Work Order ID 106892

Item Name: Floor Provisions

DART SERVICE INSTRUCTION

TO AMEND INSTALLATION INSTRUCTIONS IIN-D350-689 REV. B AND INSTRUCTIONS FOR CONTINUED AIRWORTHINESS ICA-D350-689 REV. 1

FIGURE 1: UPDATES TO CROSS SECTIONS F-F AND M-M
 With reference to Figures 5 and 7 of IIN-D350-689
 (Figures 25-5 and 25-7 of ICA-D350-689)

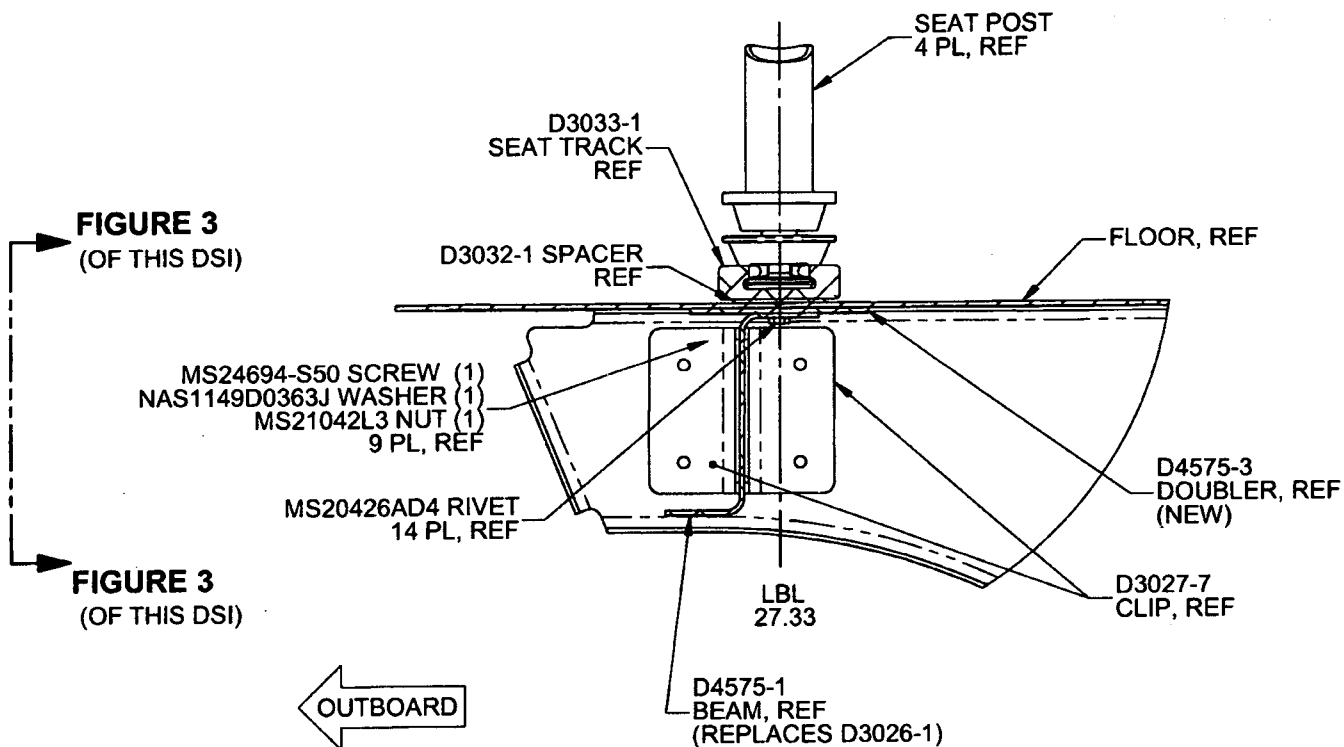
For D350-689-011/-013 at CHG 006/005 and later and D350-689-021/-023 Kits at CHG 005/004 and later, the D3026-1 Channel has been replaced with the D4575-1 Beam and D4575-3 Doubler and the D3234-3 Doubler has been removed. Consequently, the installation instructions for D350-689-011/-013 at CHG 006/005 and D350-689-021/-023 at CHG 005/004 are updated per Section 2.0 of this Service Instruction. The parts list update is shown in Section 4.0 of this Service Instruction. There is a negligible change to the weight and balance.

If there is an existing stringer at LBL 27.33, it will need to be removed from that location. Locate D4575-1 Beam, D4575-3 Doubler, and D3032-1 Spacer as shown in Figure 1 of this Service Instruction. Transfer drill existing holes from the aircraft floor to the D4575-1 Beam, D4575-3 Doubler, and D3032-1 Spacer. Ensure 1.0" to 1.5" rivet pitch and add additional holes if required. If there is no existing stringer, locate D4575-1 Beam, D4575-3 Doubler, and D3032-1 Spacer as shown in Figure 1 of this Service Instruction and drill Ø0.128" holes on a 1.0" to 1.5" pitch.

FIGURE 2: UPDATES TO FIGURE 21 (IIN-D350-689) AND 25-21 (ICA-D350-689)

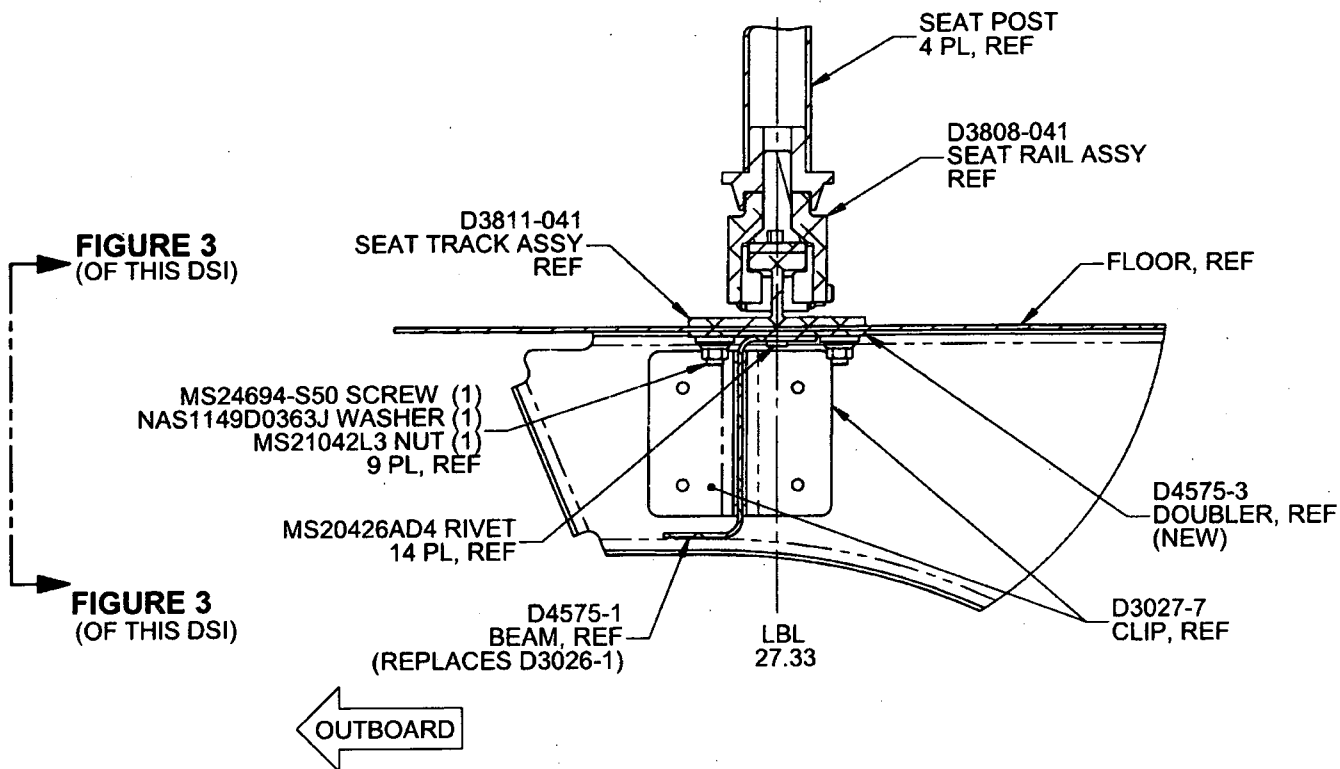
If there is an existing stringer at LBL 27.33, it will need to be removed from that location. Locate D4575-1 Beam and D4575-3 Doubler as shown in Figure 2 of this Service Instruction. Transfer drill existing holes from the aircraft floor to the D4575-1 Beam and D4575-3 Doubler. Ensure 1.0" to 1.5" rivet pitch and add additional holes if required. If there is no existing stringer, locate D4575-1 Beam and D4575-3 Doubler as shown in Figure 1 of this Service Instruction and drill Ø0.128" holes on a 1.0" to 1.5" pitch.

FIGURE 3: RELIEFS ON D4575-1/-3
(ONLY D4575-1/-3 SHOWN FOR CLARITY)
VIEW LOOKING INBOARD

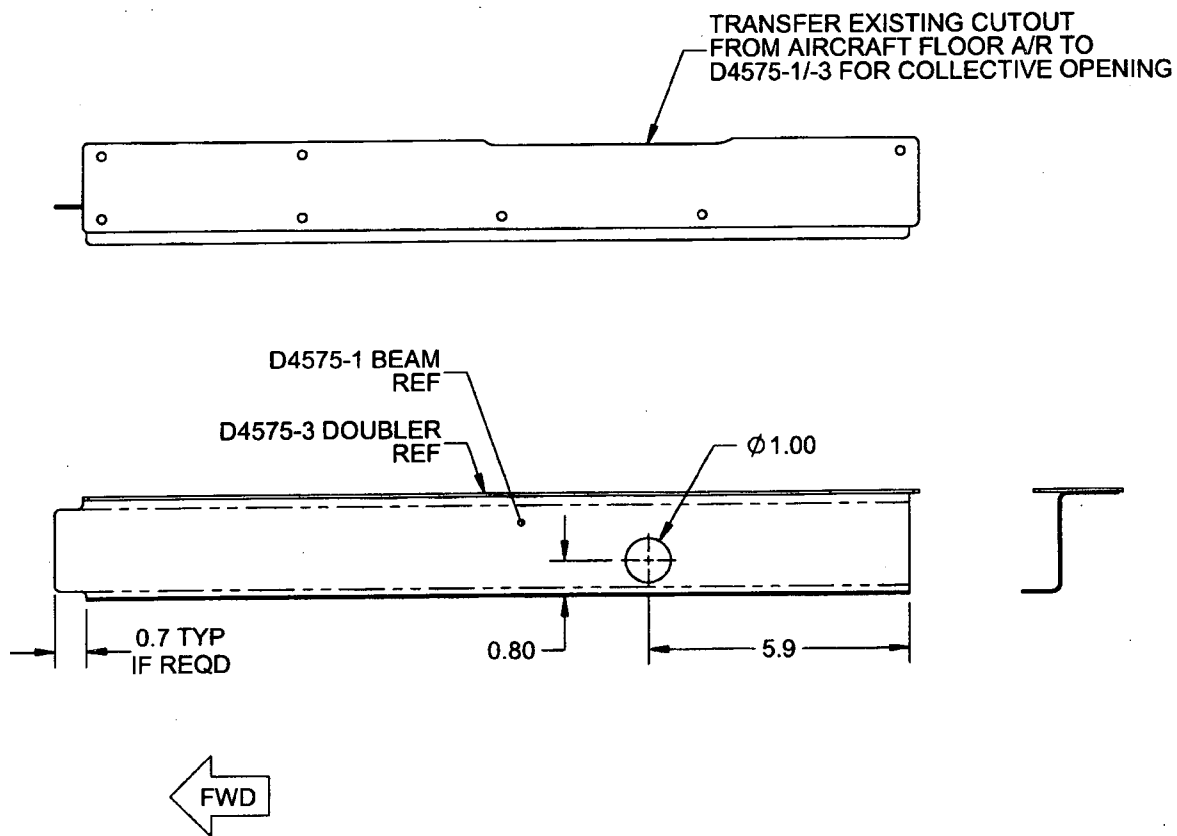
Note: Drill a Ø1.00" (Ø25.4 mm) hole in the D4575-1 Beam to clear extension tube of collective and cutout as required for clearance of collective opening and fwd bulkhead as shown in Figure 3 of this Service Instruction.

Note: Drill a Ø1.00" (Ø25.4 mm) hole in the D4575-1 Beam to clear extension tube of collective and cutout as required for clearance of collective opening and fwd bulkhead as shown in Figure 3 of this Service Instruction.
